Meeting Agenda Historic Review Board

Tuesday, May 26, 2020

3a. GLUA-20-00007/HR 20-04: Historic Review Board review of a new single-family home and detached garage in the Canemah National Register Historic District on 4th Avenue.

**Historic Review
Staff Report and Recommendation
April 21, 2020
REVISED**

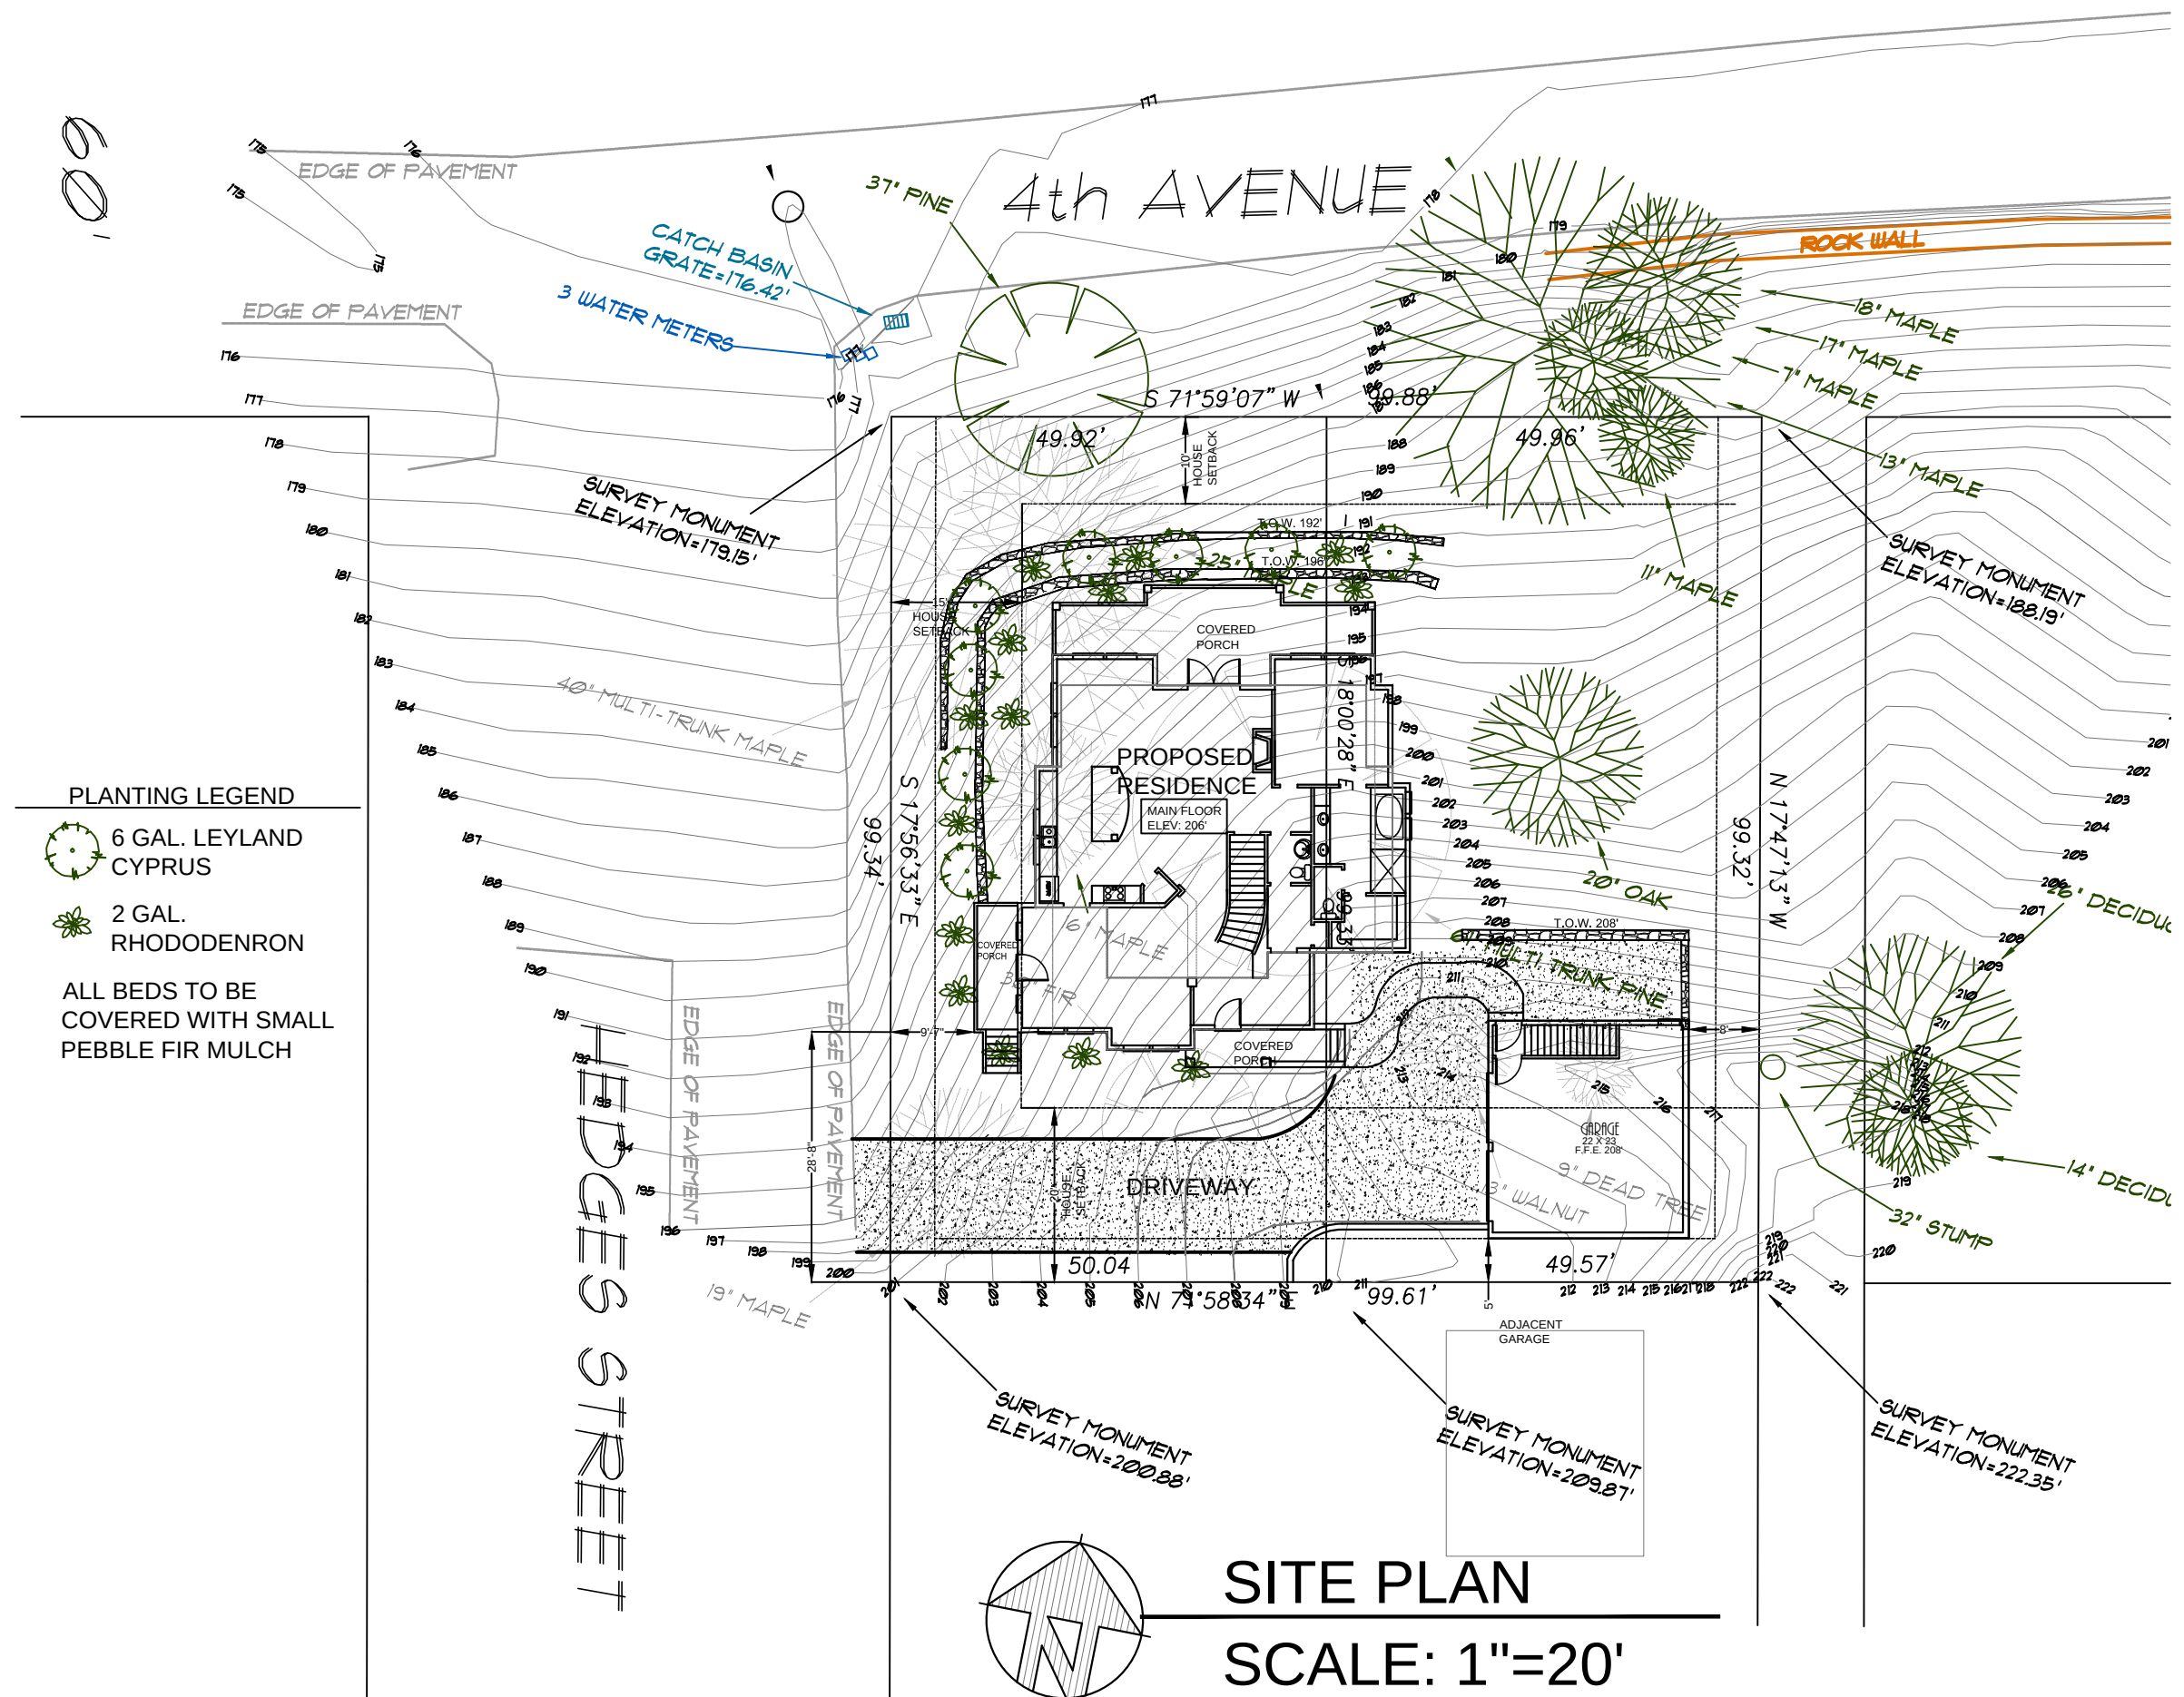
8. We have attempted to mitigate the exposure of the

lower level by reducing windows, adding concrete up higher, and adding metal trellis work for vine plantings. We are open to additional mitigation in regards to this concern within the real geometry that we have been handed.

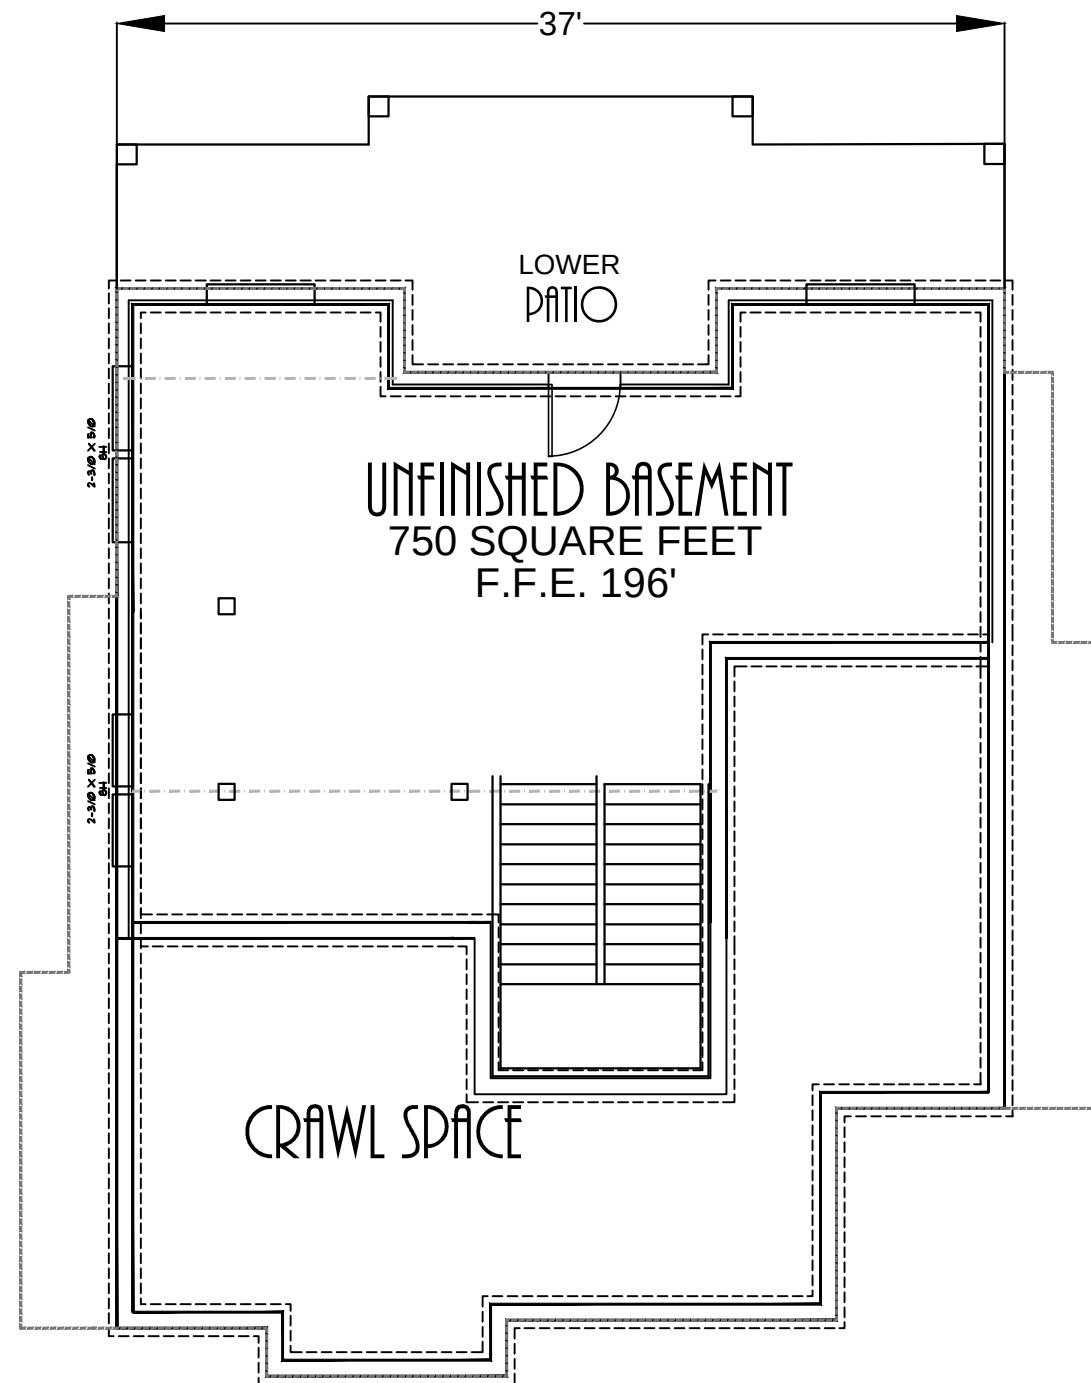
14. We have reduce the grade width of the house to 37' as stipulated.

Front (North) elevation (Revised – March 2020 Plans)

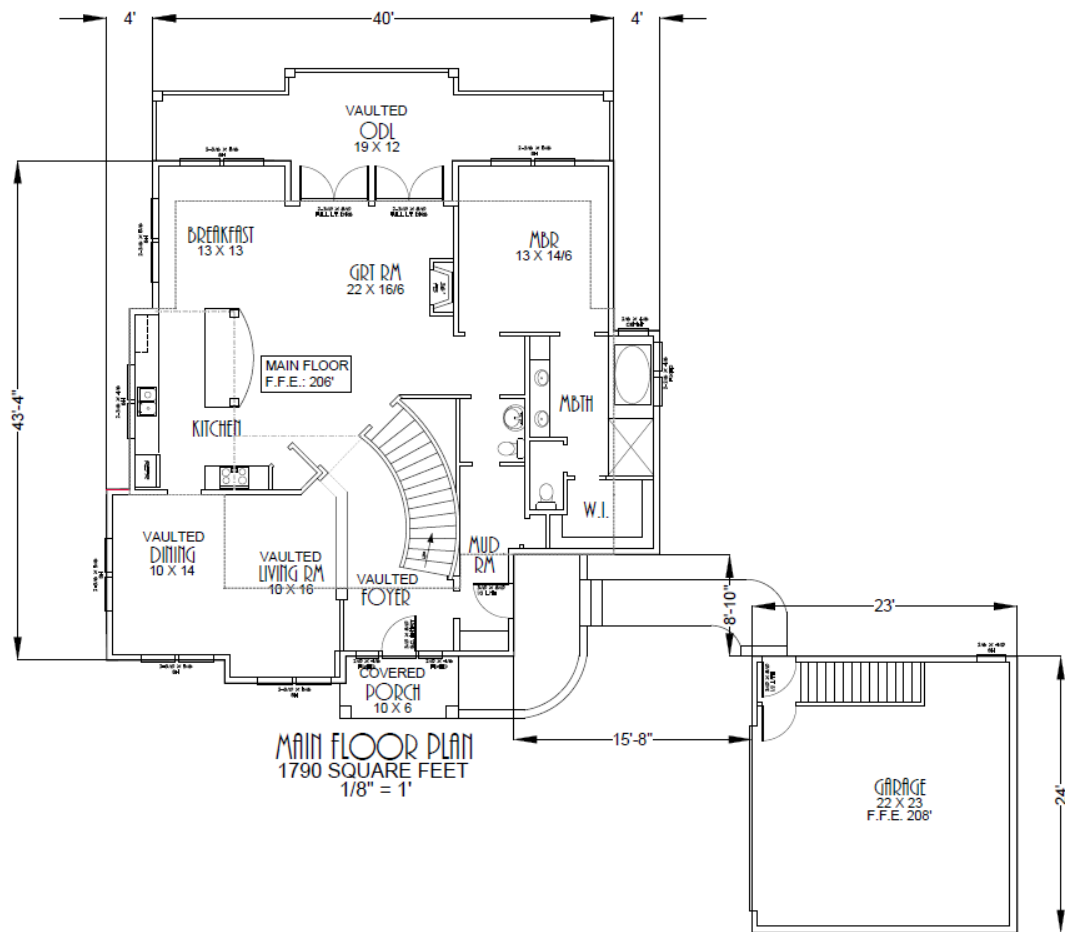
The applicant submitted a revised site plan, floor plans, and North and South elevation plans. The site line plans and East and West elevation plans were not provided in the revised set of plans and included and identified below for reference.
